Ohio Museum Complex HVAC
Lin Hall, The Ridges – Ohio University
Athens, Ohio

ADDENDUM 02

Addendum to the drawings and specifications for: **Ohio Museum Complex HVAC**

E4

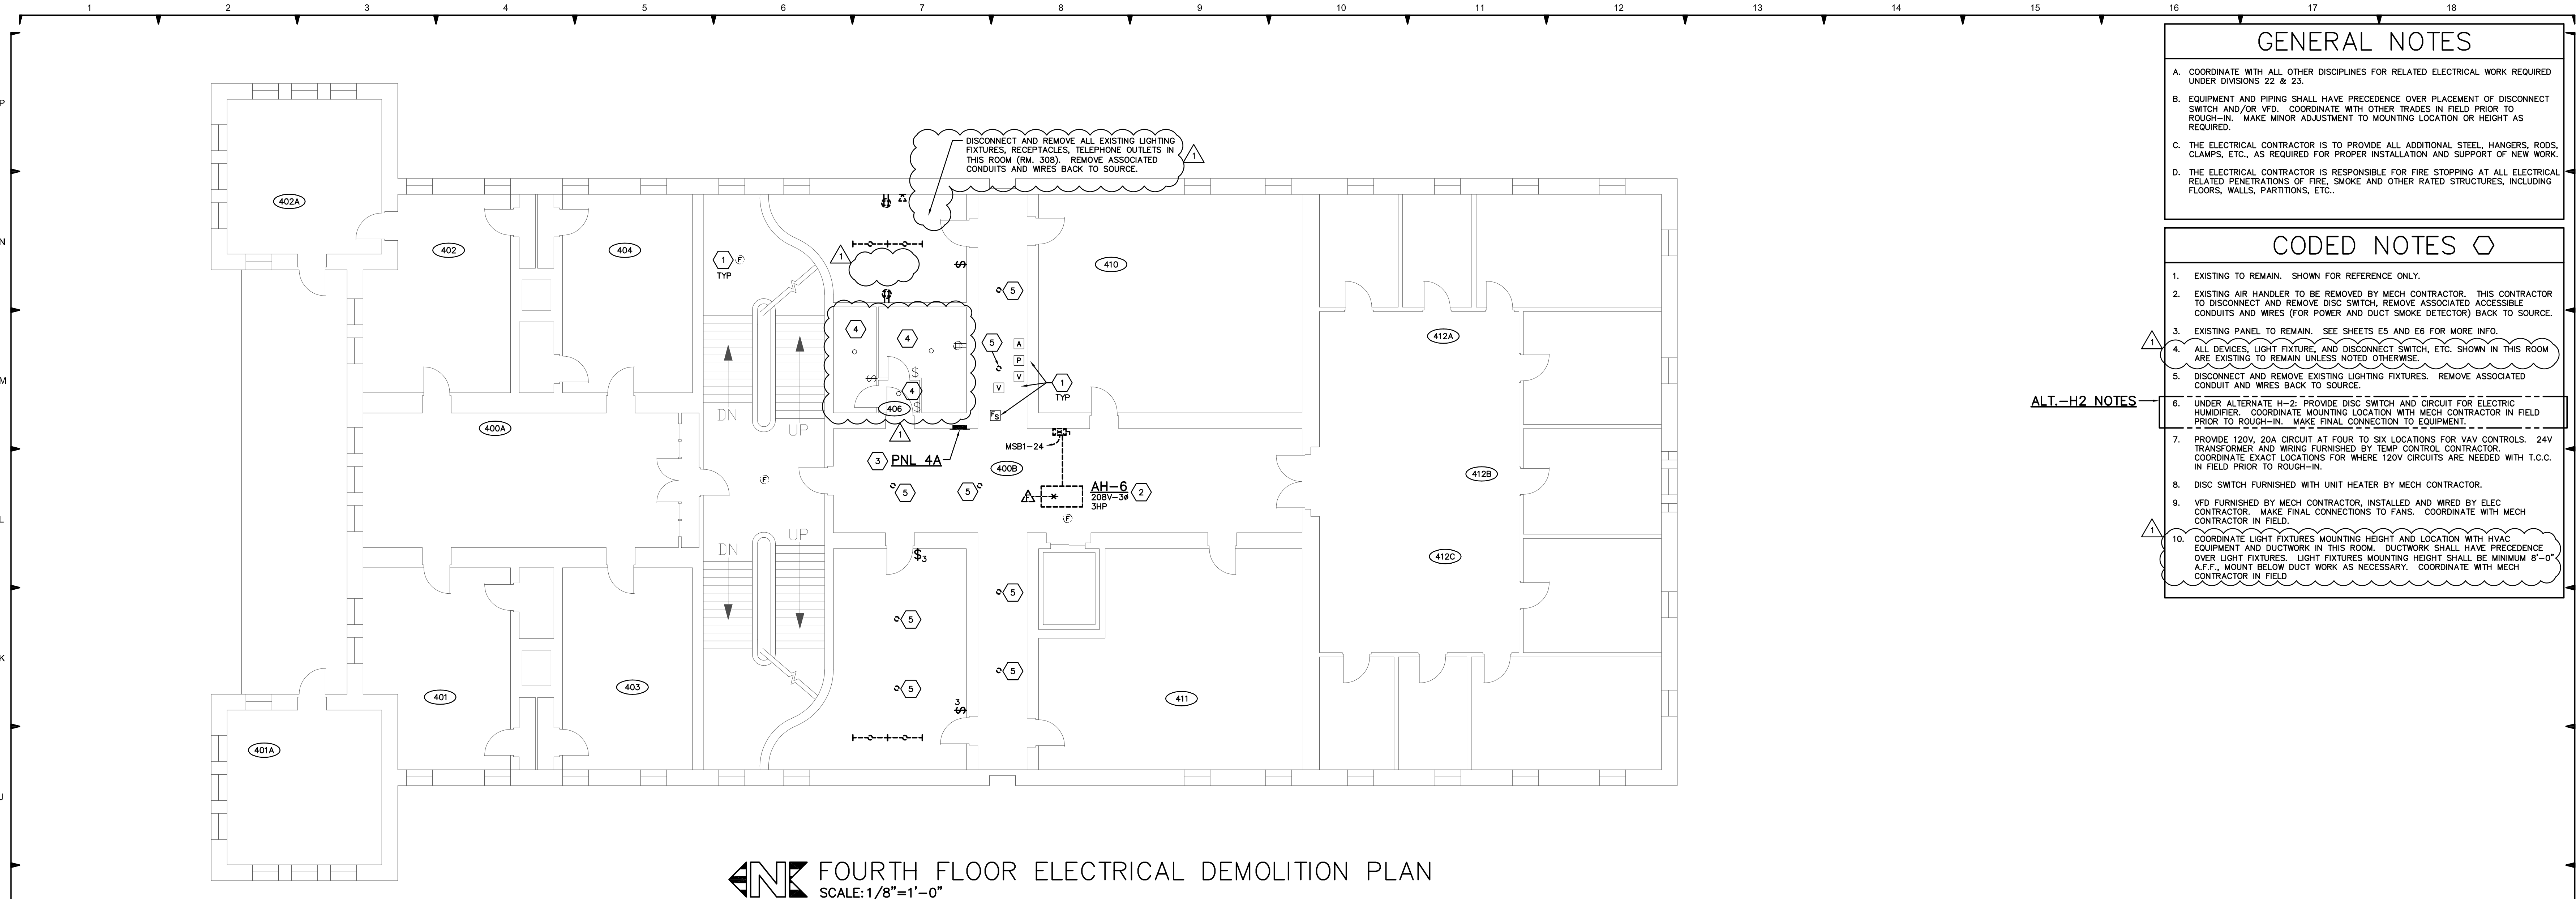
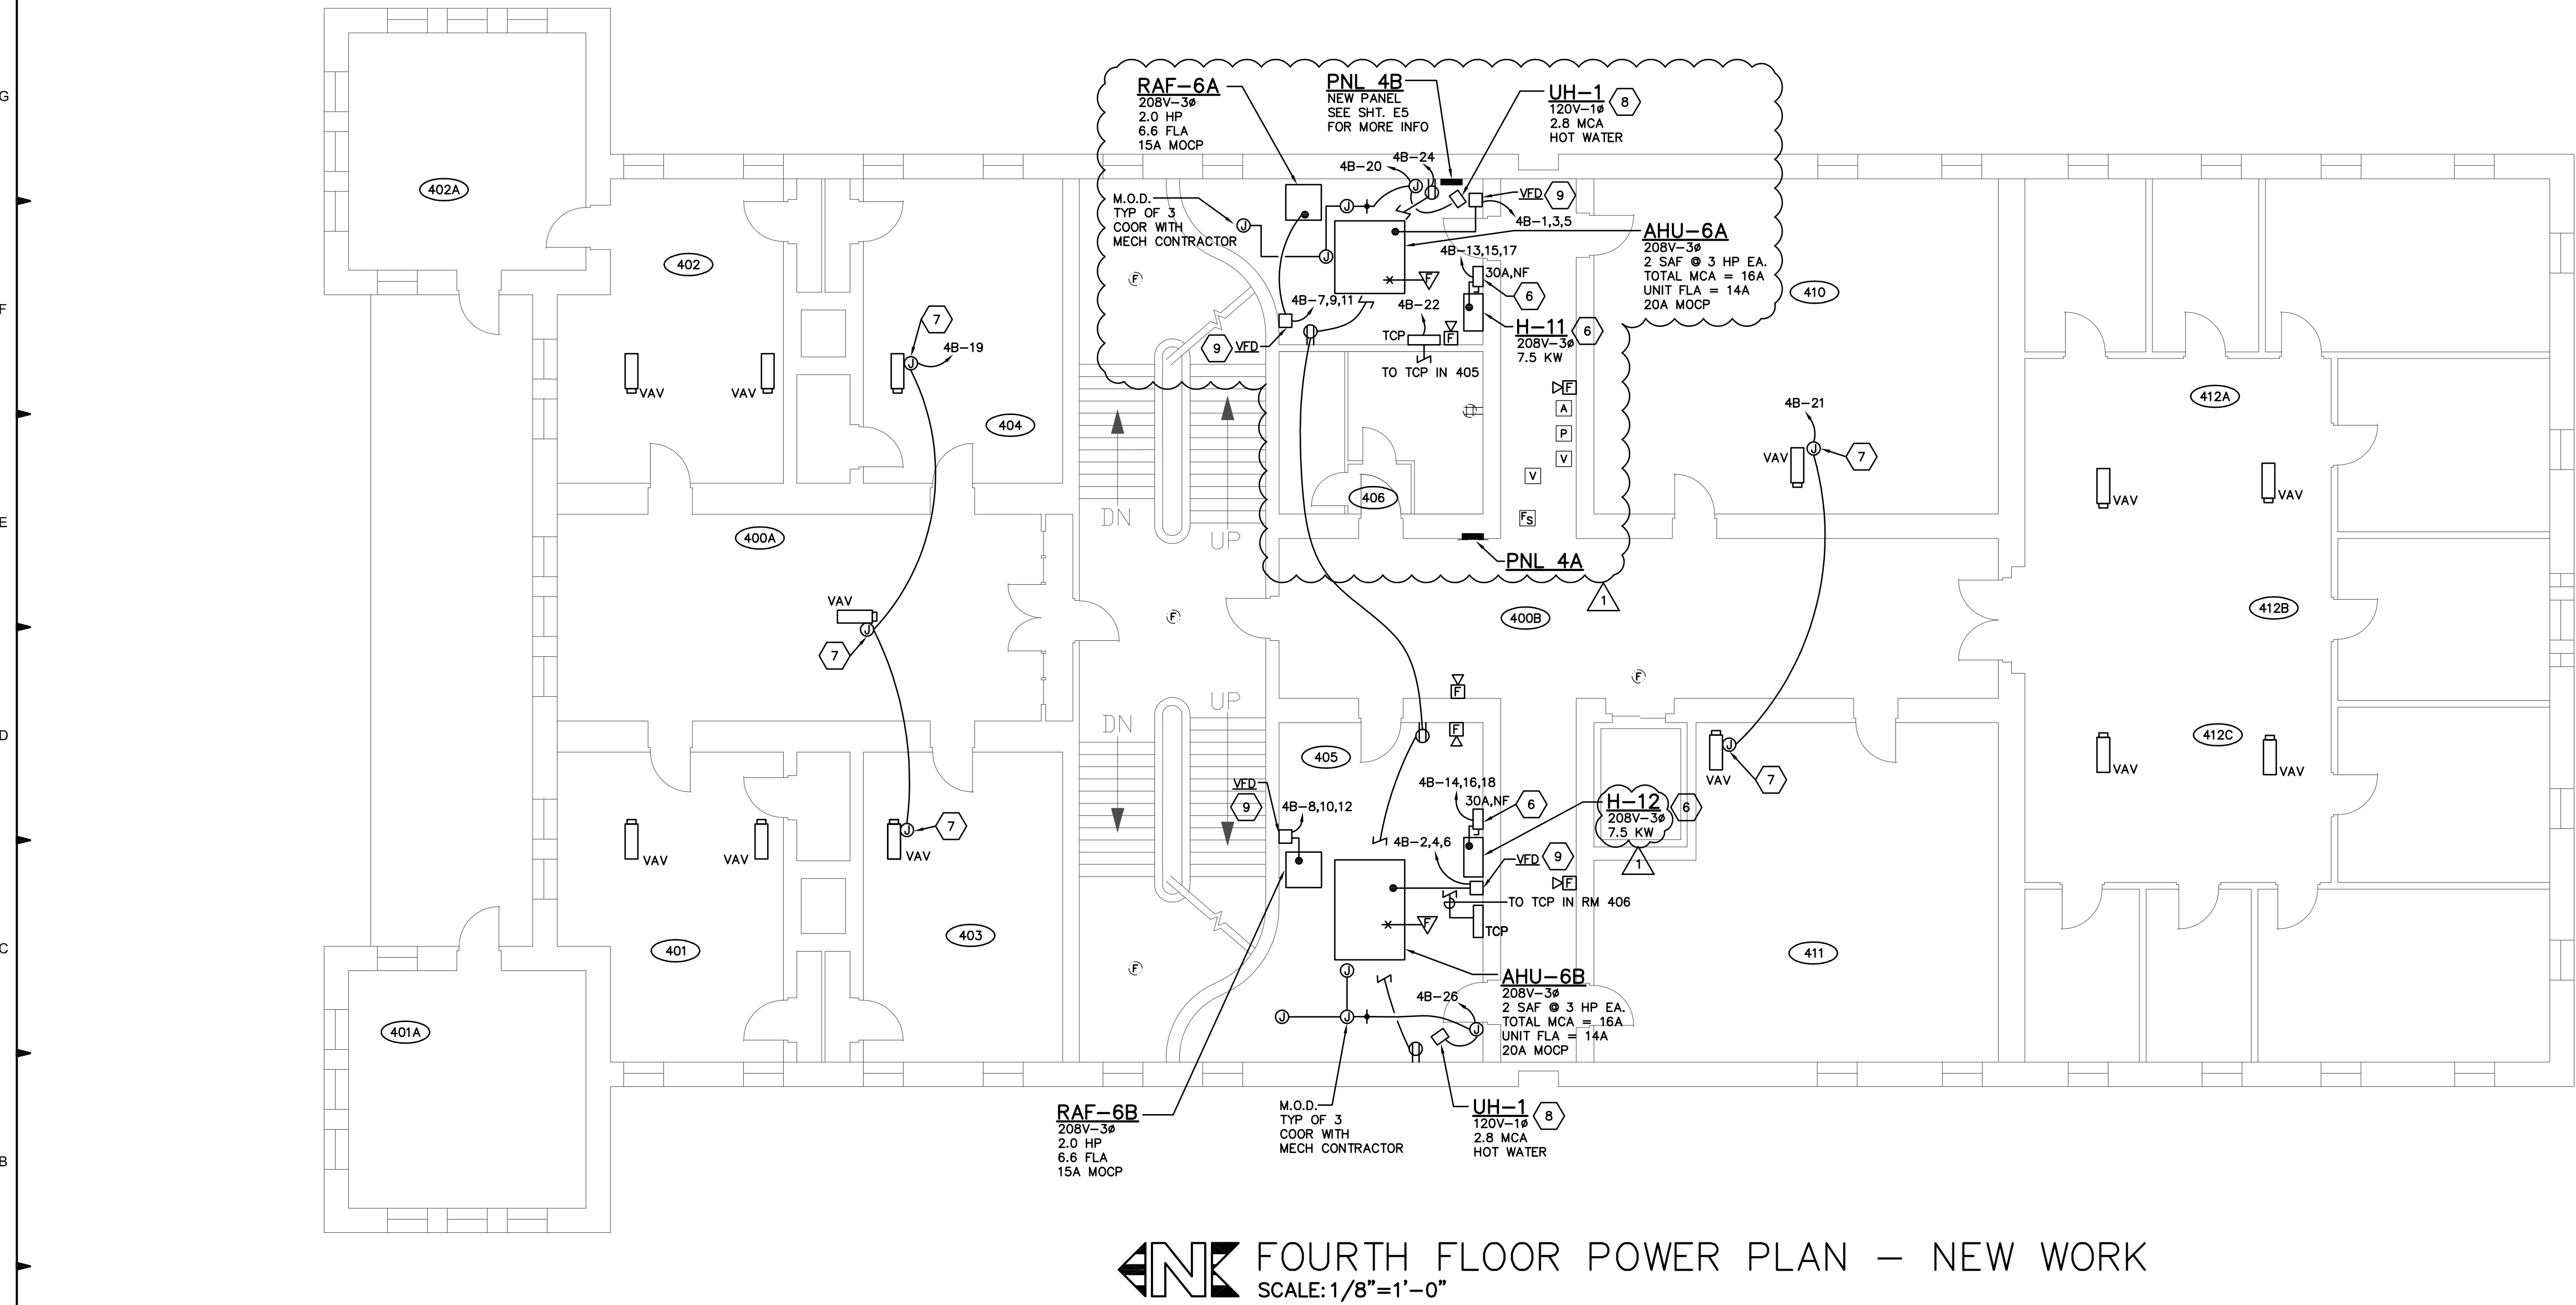
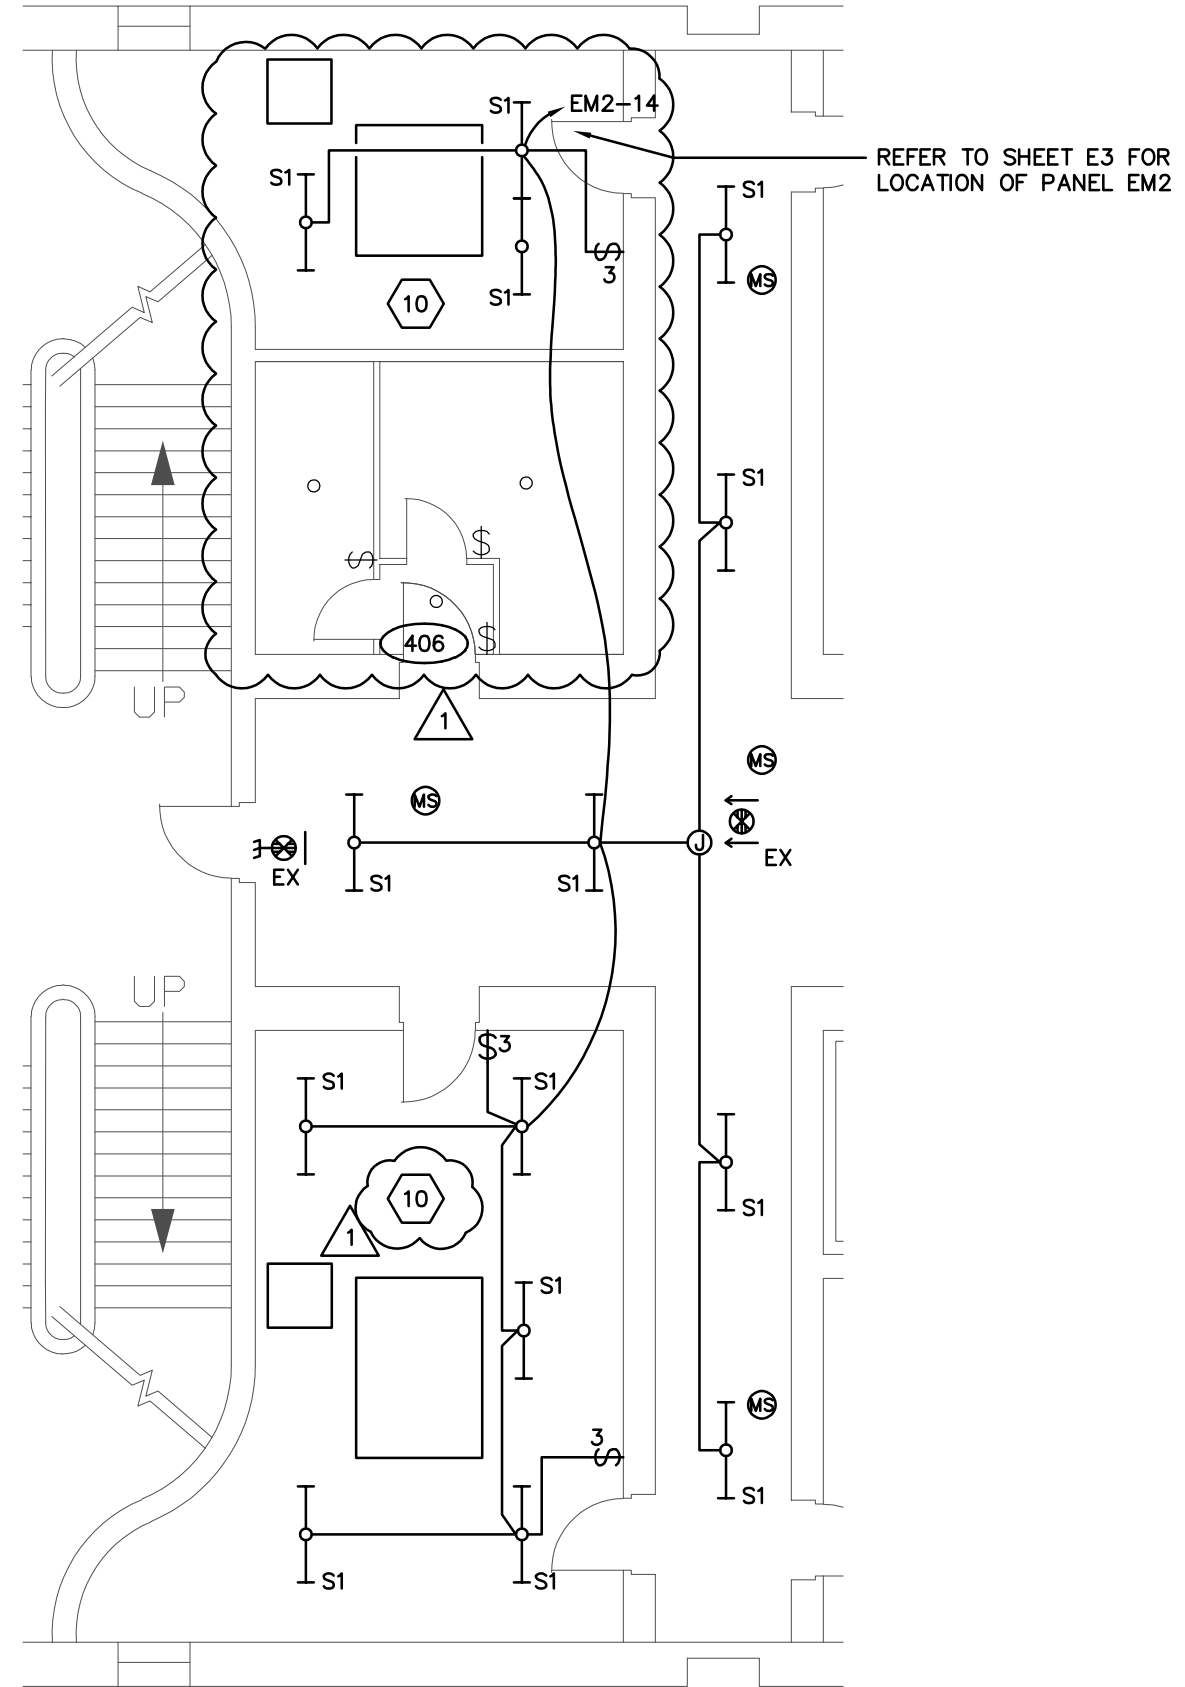
- 12. Sheet E3**
Revisions for AHU.
- 13. Sheet E4**
Revisions for AHU.
- 14. Sheet E6**
Panel revisions.
